Subject: RZN22-0004 Glade Spring Crossing

Subject: Response to RZN 22-04 – Grade Springs Crossing Creek Valley Overlay Modification and Disturbance Request at 1006 Glade Road (Tax Map No. 225-A 3).

Subject: RZN 22-0004 – Glade Spring Crossing Creek Valley Overlay Modification and Disturbance Request at

Subject: RZN22-0004 Glade Spring Crossing STAFF PROFFER EVALUATION

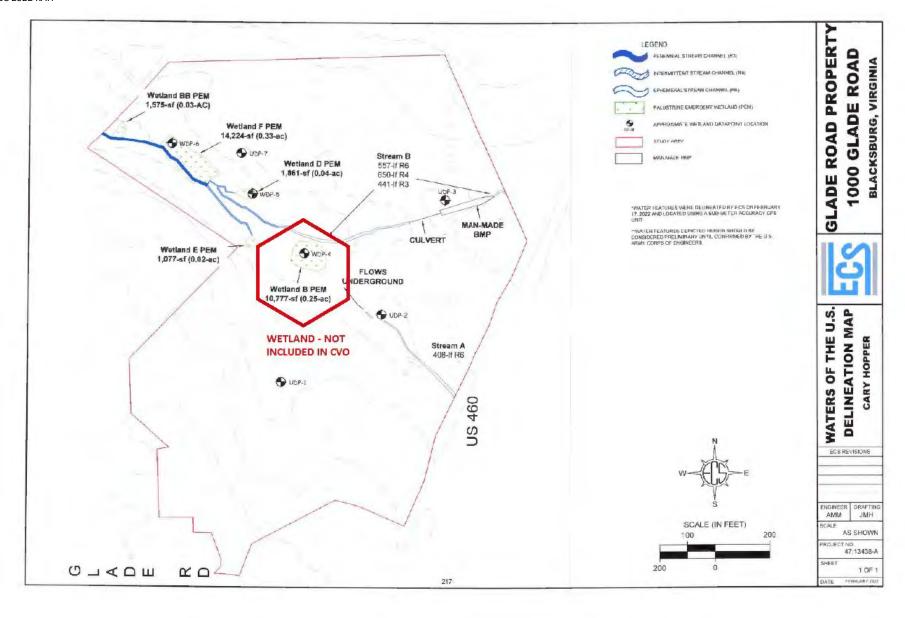
- This request is within the Toms Creek basin and adequately defines the 100-year floodplain, subsequent to the Town Flood study review comments.
- This request references a certified survey performed by Ralph L. Clements, LS and from photogrammetric mapping prepared by Joseph M. Kovach. The photogrammetric ground surface was produced to meet 0.3 foot vertical accuracy in clear, unobscured areas. This survey information confirms the areas adjacent to the floodplain that have 25 percent or greater slopes.
- ECS has provided a map of the waters of the US (see image on page 3) and this illustrates wetlands that are contiguous to the 100-year floodplain that are <u>not</u> included in the amended Creek Valley Overlay map. These areas should be included in the revised CVO to be consistent with Sec. 3231 of the Town Code.
